SERVICE BULLETIN

85

TITLE
INSPECTION FOR AXLE BURRS AND REVISED MAINWHEEL TORQUE INSTRUCTIONS
CLASSIFICATION

T67B, T67C Series, T67M, T67M-MkII, T67M200 (All Post Mod M468 - Fairey Hydraulics Undercarriage), T67M260 and T67M260-T3A

FIG 1

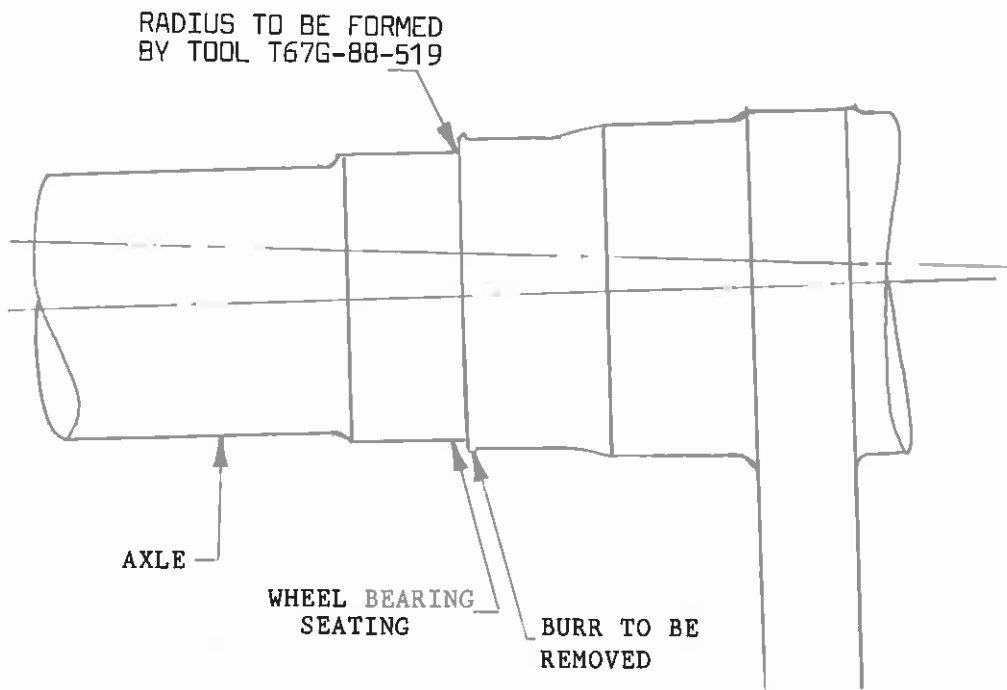
1. At next removal of wheel inspect axle for burring Ref. Fig. 1.
2. If burr exists, remove burr taking the following action:

- i) Carefully rub down burr to original diameter, by hand, using carborandum stone, and clean off all abrasive dust.

- ii) Using tool T67G-88-519 remove any burrs on inner bearing shoulder. The tool will also form corner radius at shoulder base. Ref. Fig. 1.

The tool is designed to be operated by hand using a twisting action with a light pushing force. Continue cutting action until burr is removed and radius fully formed.

Note: Tool will not cut after the radius has been fully formed.
